Monticello Nuclear Generating Plant
2807 W County Rd 75
Monticello, MN 55362

L-MT-15-065
10 CFR 50.90

License Amendment Request for AREVA Extended Flow Window
Supplement to Respond to NRC Staff Questions (TAC No. MF5002)

**Response to
Requests for Additional Information**

SRXB/SNPB RAI-3, EO-III Solution

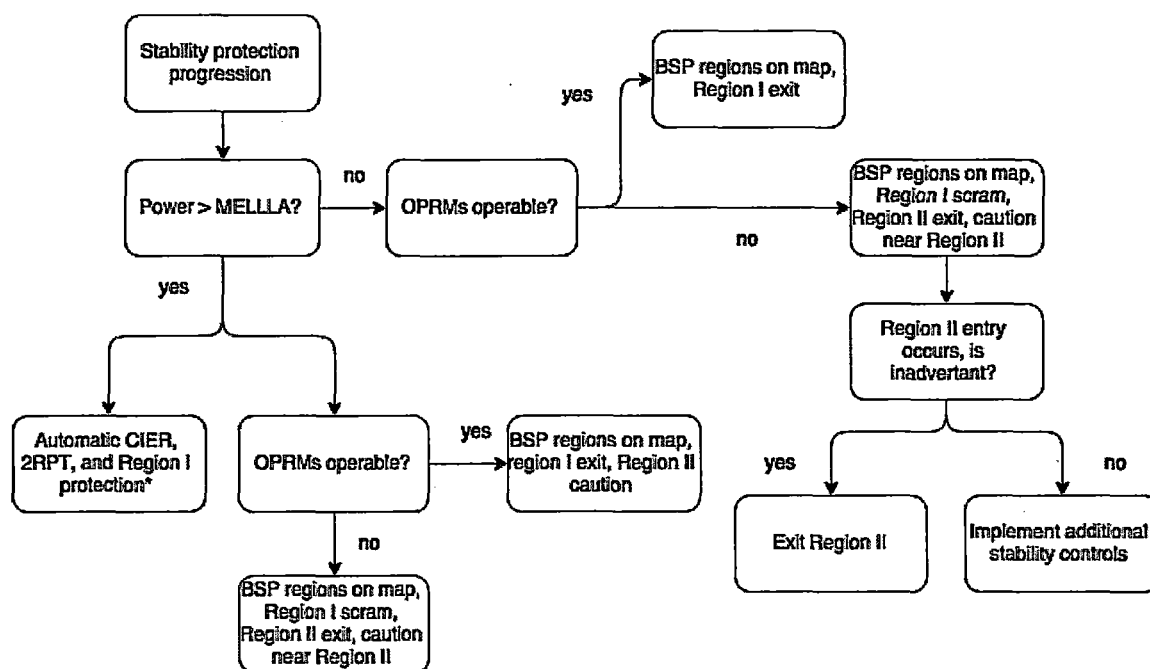
- a) *Provide a roadmap and explanation of how the Extended Flow Window Stability (EFWS) trip is defined and implemented in technical specifications and COLR.*
- b) *Define the methodology/process to calculate the EFWS trip on cycle specific basis.*
- c) *Provide a justification for the removal of manual Backup Stability Protection (BSP) from section 5.6.3 of Technical Specifications.*

- a) The EFWS trip is defined in Xcel Energy Engineering Evaluation (EE) EC 25987, in accordance with AREVA Topical Report ANP-10262(P), Enhanced Option III Long Term Stability Analysis, Revision 0, January 2006 and NRC requirements. This EE, which describes the use of uncertainties, flow mapping, and the use of setpoint

methodology, is a method used to develop a cycle-specific value provided in the COLR per TS 5.6.3. The EFWS trip setpoint may vary on a cycle-specific basis because it is based on Region I; so the setpoint is reported in the COLR. The EFWS rod block setpoints are calculated along with the EFWS trip setpoints (in the fuel cycle design process), but the rod block setpoints are reported in the TRM to be consistent with other rod blocks associated with TS trip functions.

The progression of stability protection, per TS LCOs 3.3.1.1.I, 3.3.1.1.J, and 3.3.1.1.K are described on the flow chart below.
